**Market Street  
Marine Terminal  
Functional Replacement Project  
Portsmouth, NH**

# **NHDES Wetlands Permit Application Amendment & Request for More Information Response**

**NHDOT Project 15731  
Federal Project A000(909)  
NHDES File No. 2022-00429**

**RE: NHDES Request for More Information Response  
Standard Dredge and Fill Wetlands Permit Application (RSA 482-A)  
NHDES File Number: 2022-00429  
Subject Property: Market Street Marine Terminal, Portsmouth, Tax Map #119, Lot #5**

PROJECT No.:	5213
CAD DWG FILE:	0213_pem_01_C-105.dwg
DESIGNED BY:	SND
DRAWN BY:	DLM
CHECKED BY:	NJE
SCALE:	AS SHOWN
<b>C-105</b>	
SHEET 12 OF 18

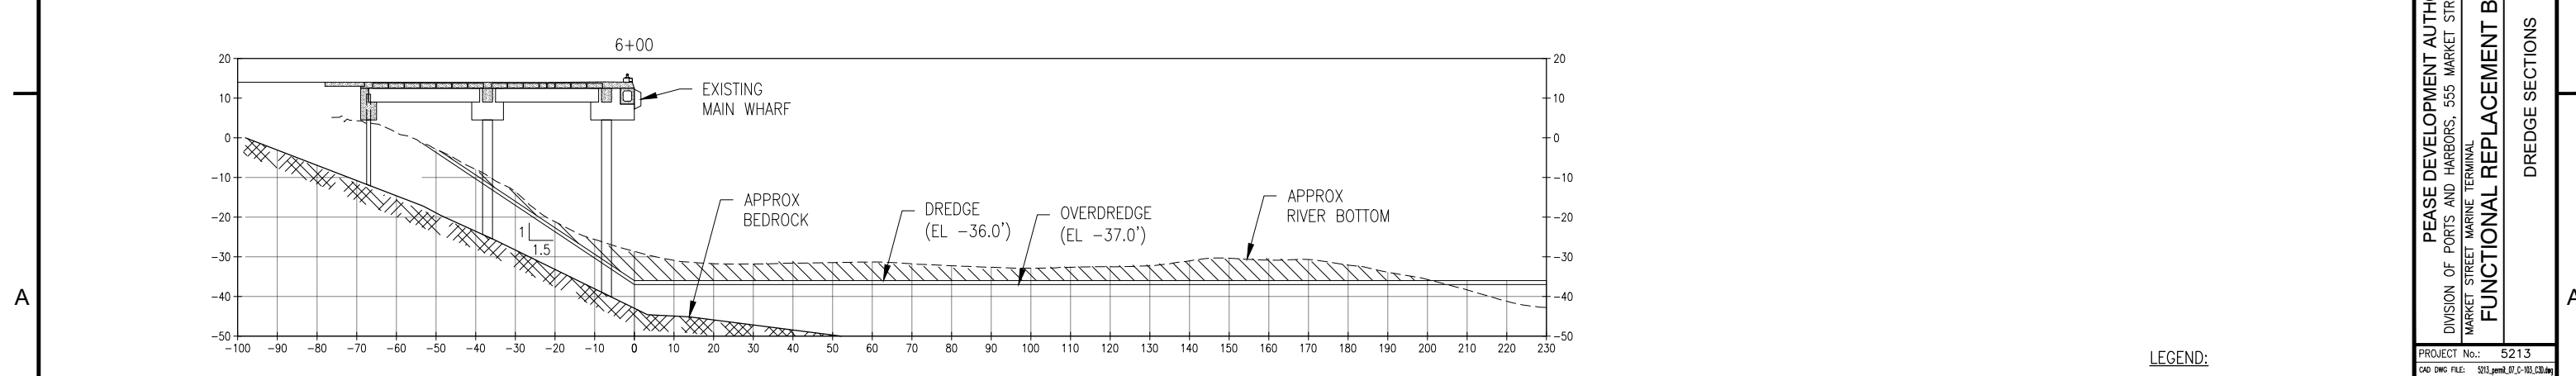
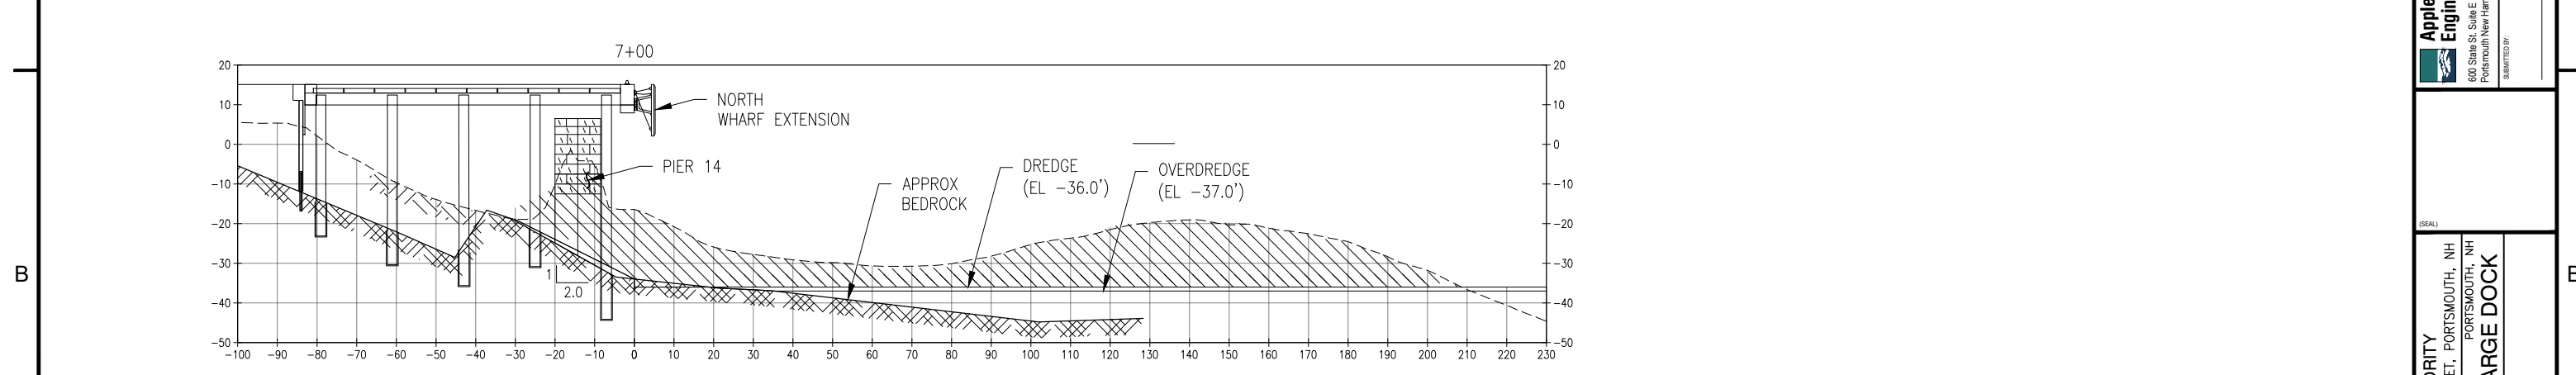
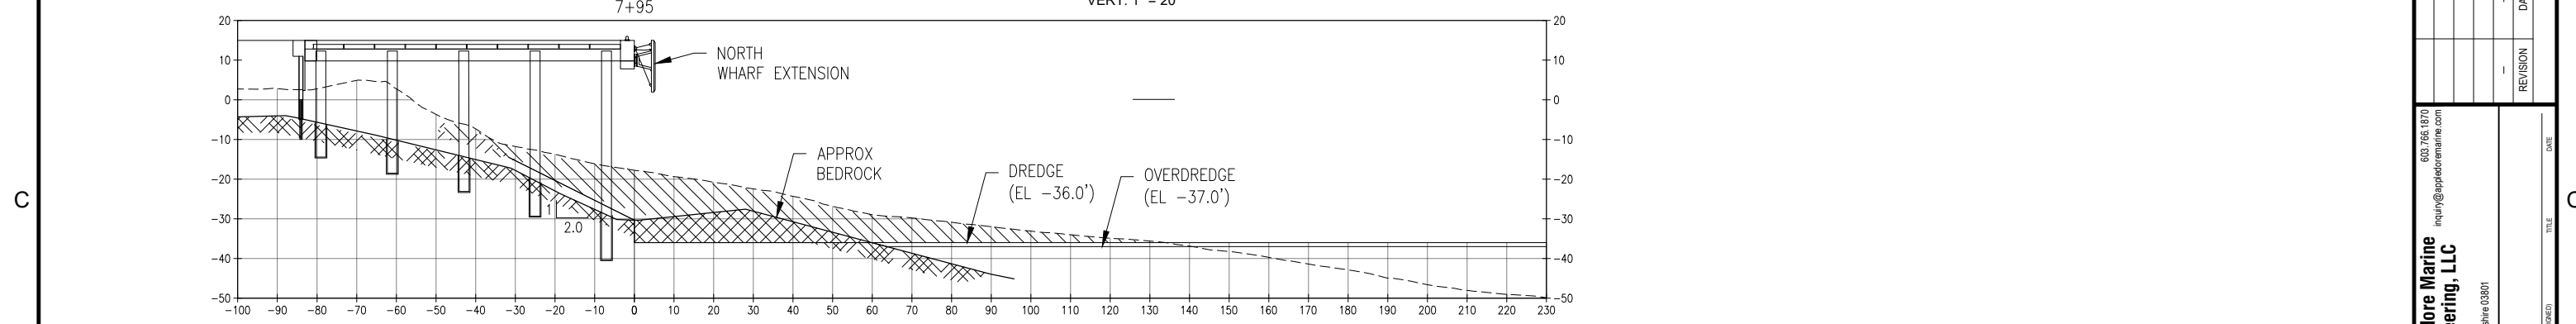
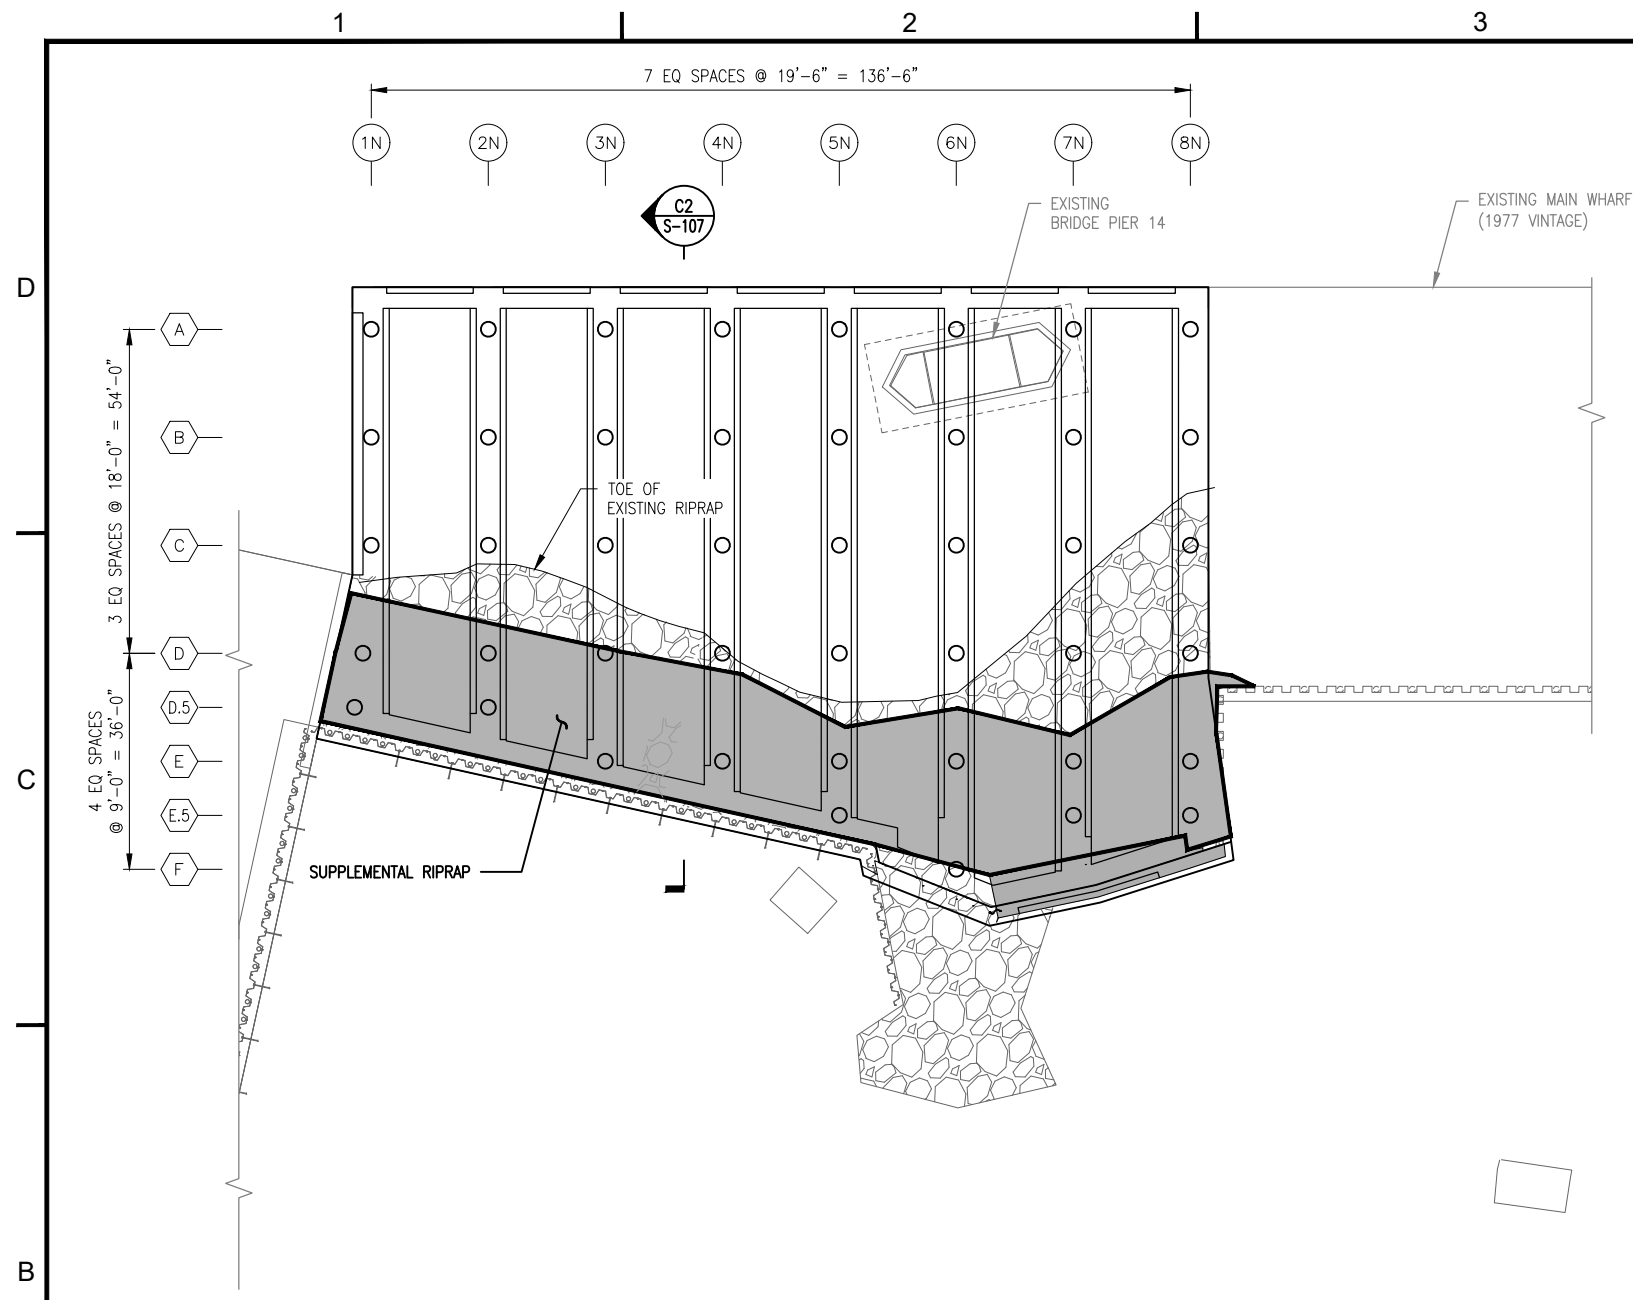
17. Please revise the plans of the proposed dredge area to include cross section details showing the existing and proposed contours within the proposed dredge area at multiple locations through the proposed dredge area in accordance with Env-Wt 501.02(a)(2)(n).

*Please refer to Sheets 11 and 12 of the revised plan set for the proposed dredging area, cross section and profile. The Contractor will be required to complete a pre-dredge and post-dredge hydrographic survey.*

C-107  
SHEET 14 OF 18

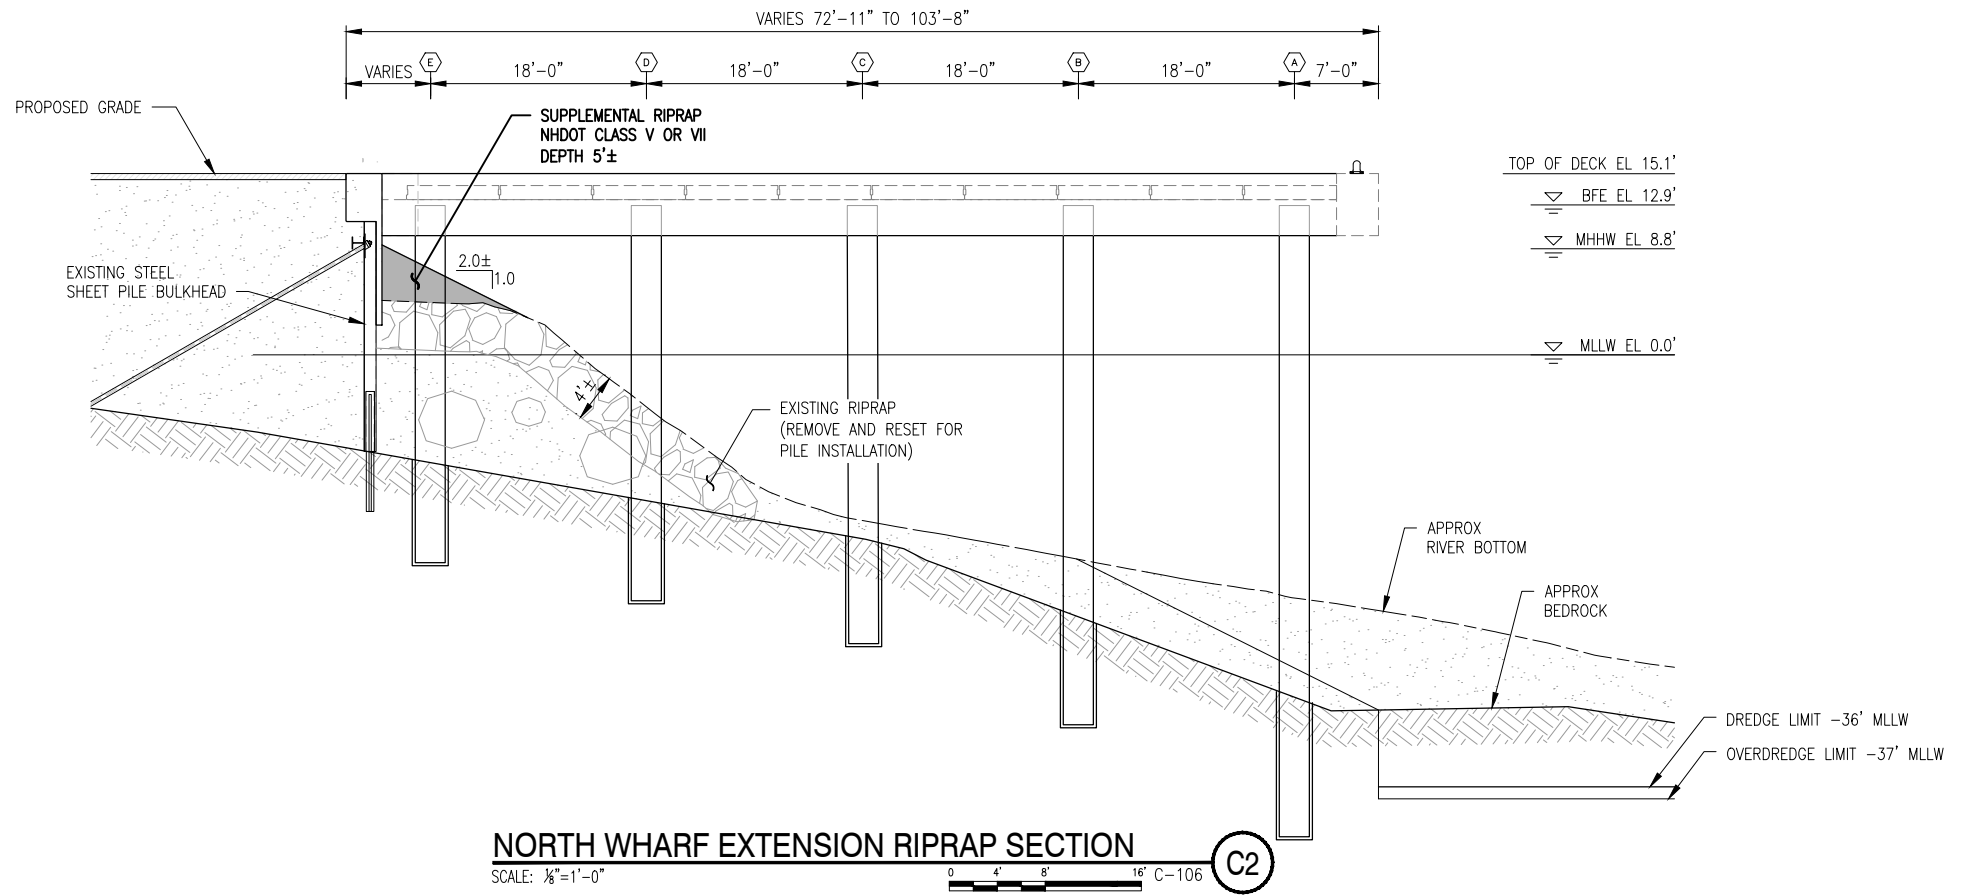
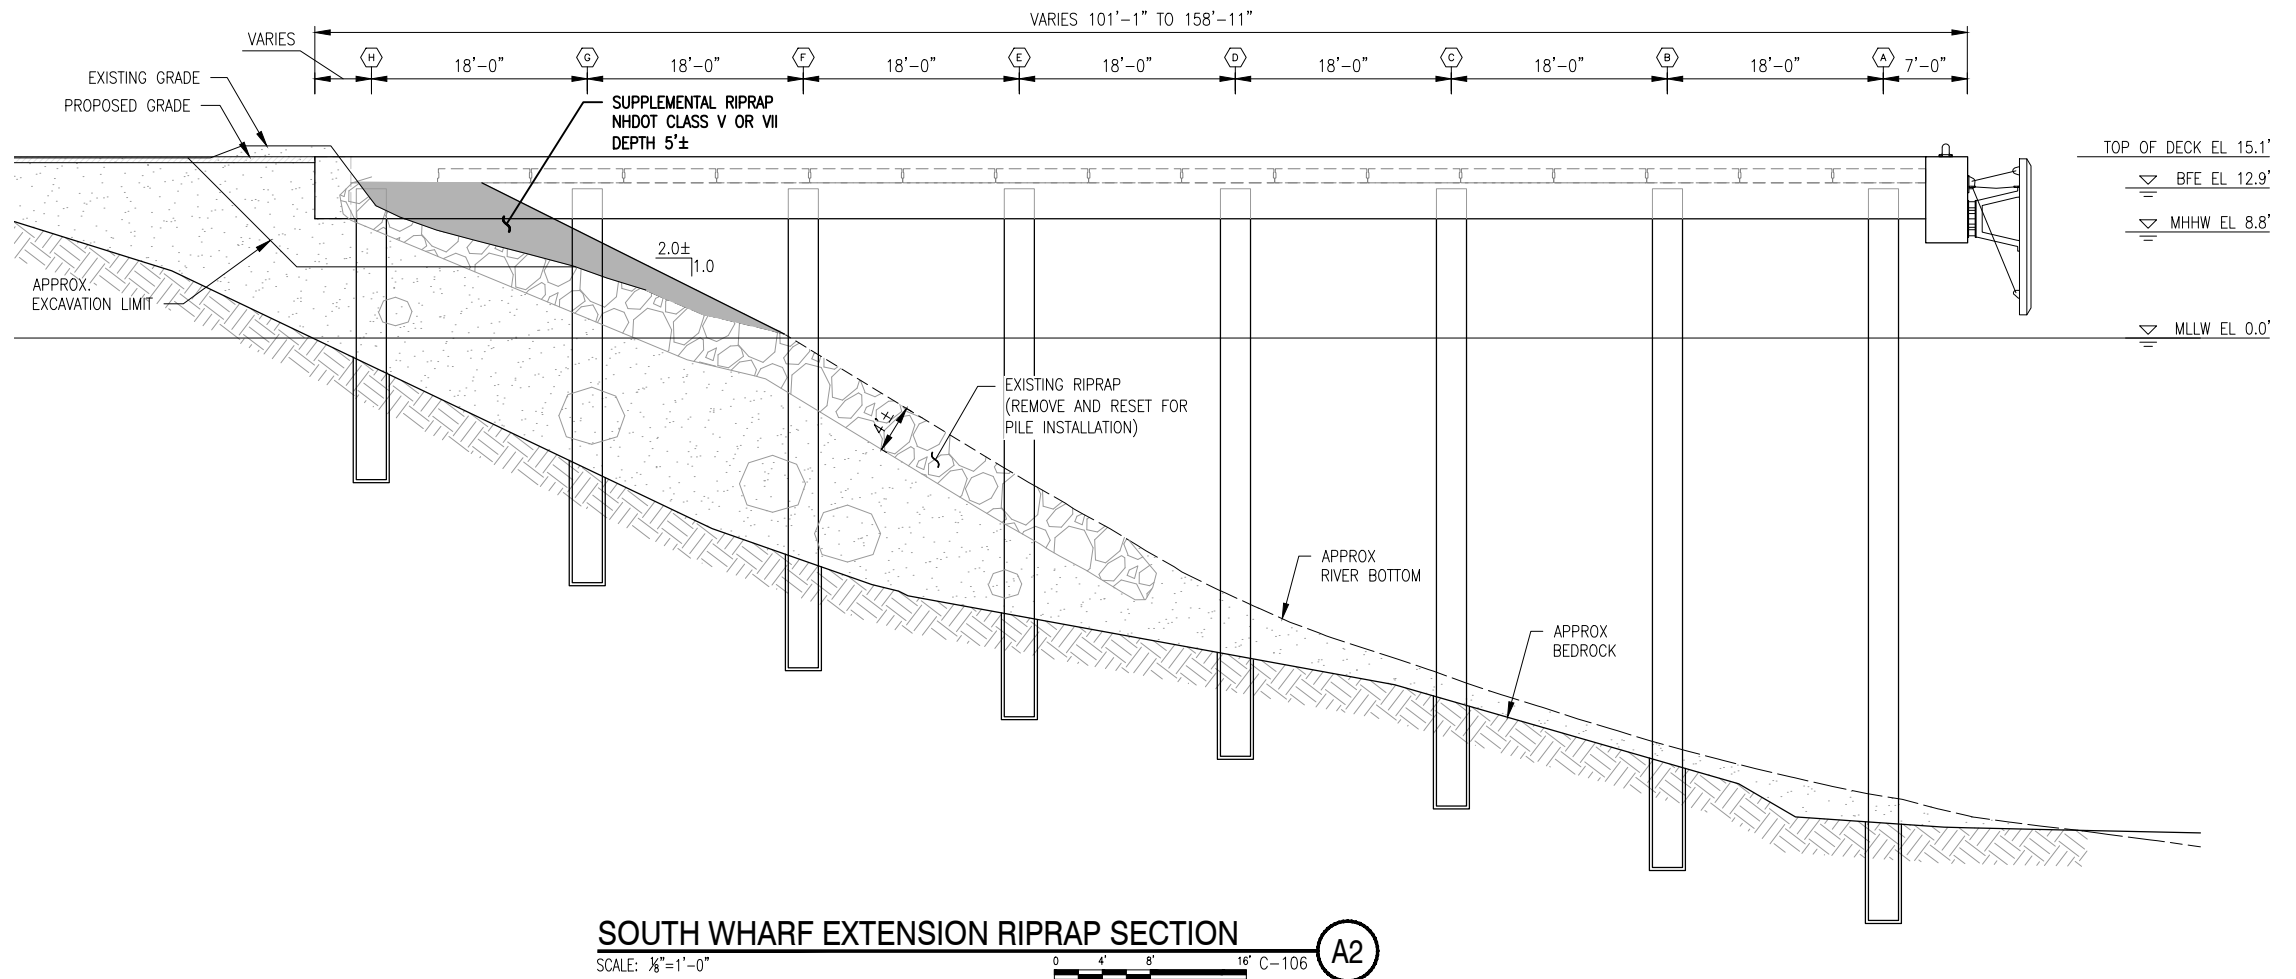
- f. As this project involves construction of a steel sheet pile retaining wall in tidal waters, the information required by Env-Wt 404 as required in accordance with Env-Wt 501.02(a)(2)(s).

*Riprap is proposed along the southern and northern wharf extensions within areas where riprap is currently installed. Refer to Sheet 14 of 18 of the revised plan set for additional information. The additional riprap would not expand upon the footprint of the existing riprap. Additional riprap material would be installed ovetop existing riprap. The shoreline at this location has been armored with riprap due to the velocities of the Piscataqua River, turbulence from vessels, restricted space, and presence of critical infrastructure.*

*The sizes and particle size distribution are summarized in the Riprap Summary Table on Sheet 14 of 18.*
